<b>AT602167MQ</b> - MUON BARREL CHAMBERS DETAILED, SECTOR 15	<b>NTB_0003</b> - TB WARM STRUCTURE - SIMPLIFIED 3-D OBJECT	Clearance	22.5 mm			Warning
			$\Delta X \approx 0$	$\Delta Y \approx -22.5$	$\Delta Z \approx 0$

Sector 15

AT602167MQ - MUON BARREL CHAMBERS DETAILED, SECTOR 15	NTB_0005 - TB WARM STRUCTURE - RING OF THE VOUSOIRS, STRUTS	Clearance	1.5 mm			Warning
			$\Delta X \approx 0$	$\Delta Y \approx 1.5$	$\Delta Z \approx 0$

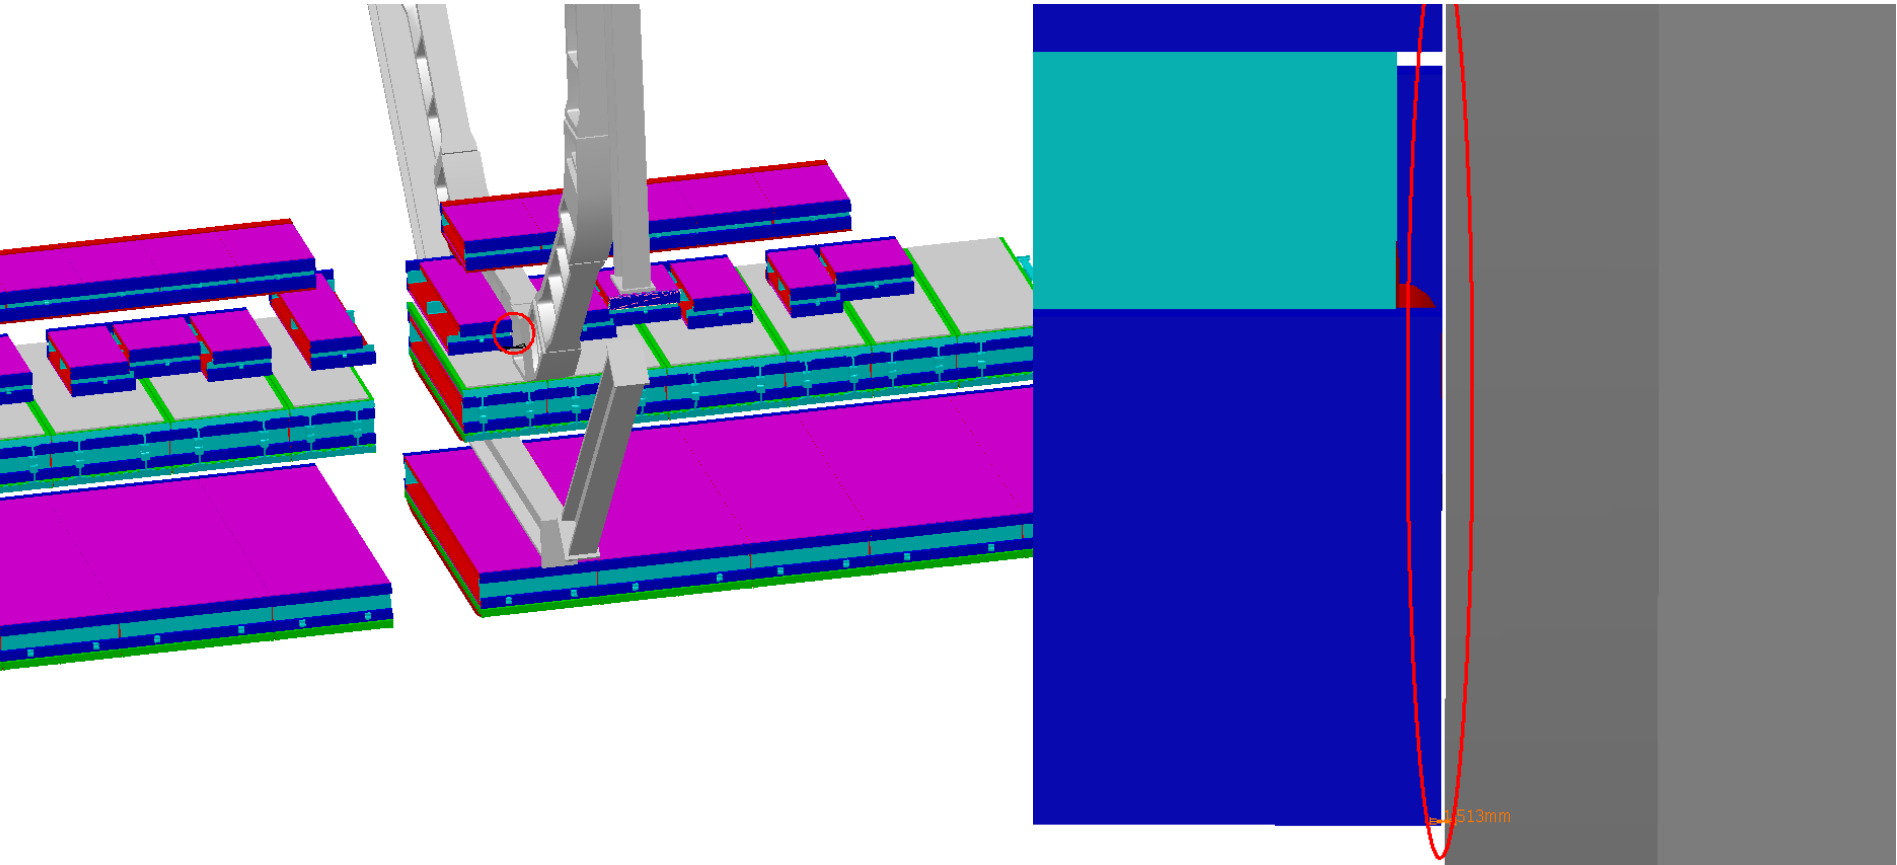
Tatiana: Check with VTB

Lasha: I have checked with VTB, cutout exists. Clearance is 27mm.

NTB\_0007 - TB FEET COIL - SECTOR 14

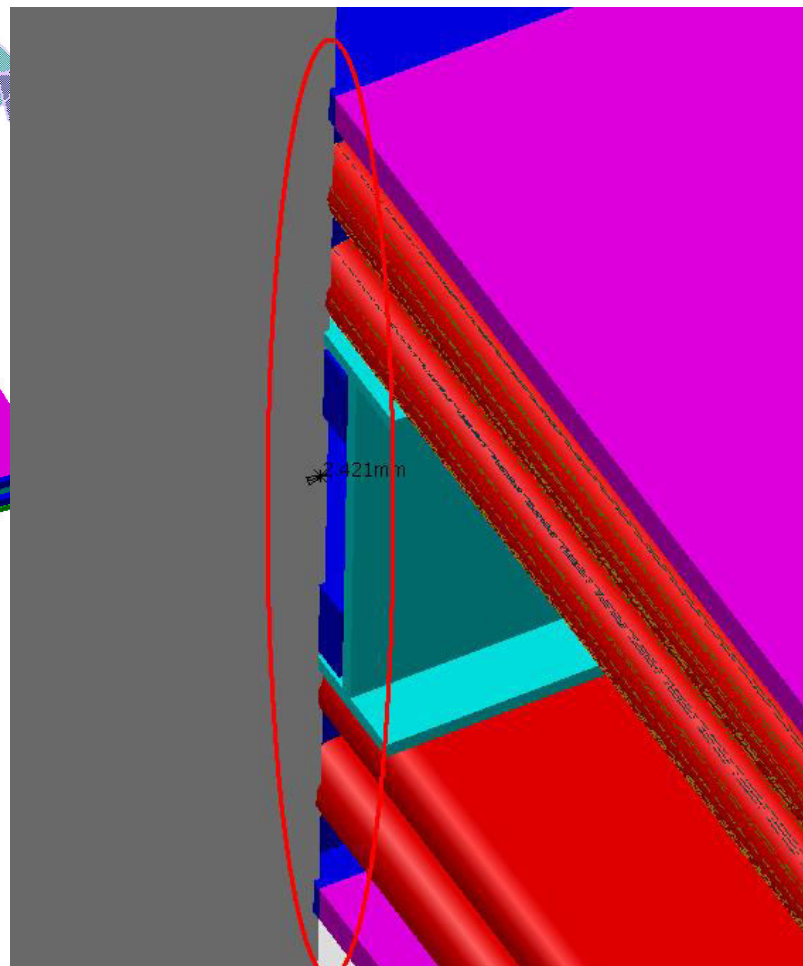
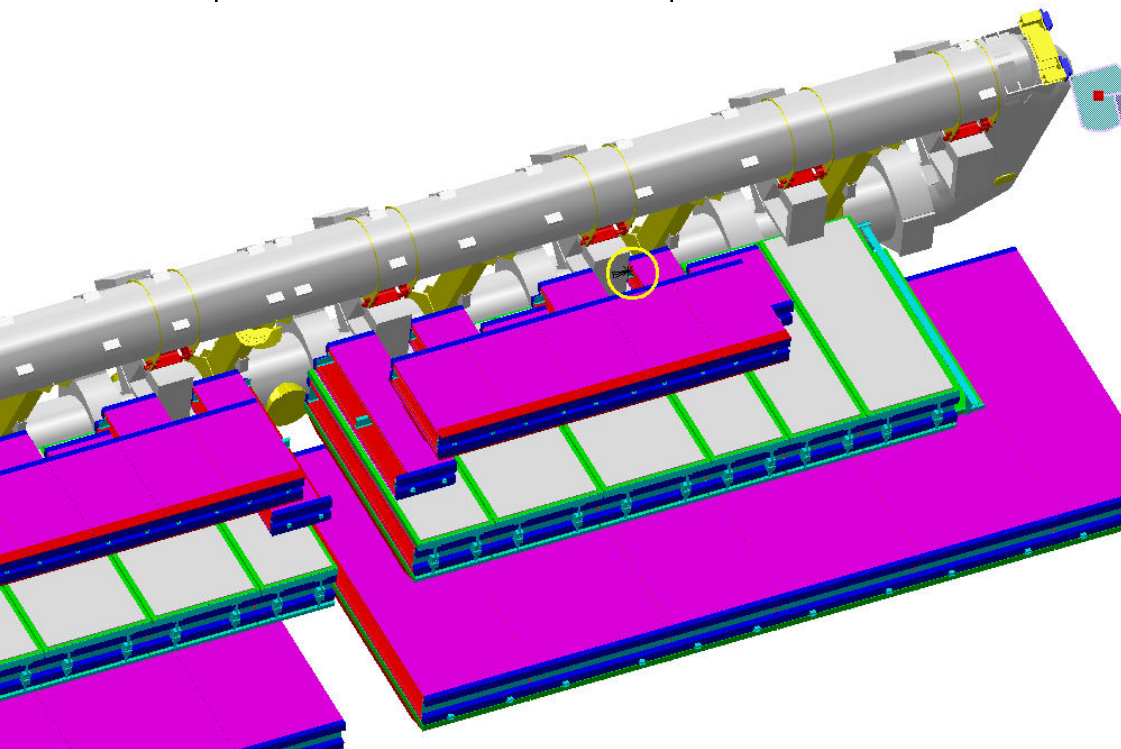
Clash value: ~ 2.4 mm

Tatiana: Check with VTB

The identical clash exists on the opposite side

Lasha: I have checked with VTB, cutout exists and there is no clash, however clearance is 22mm.
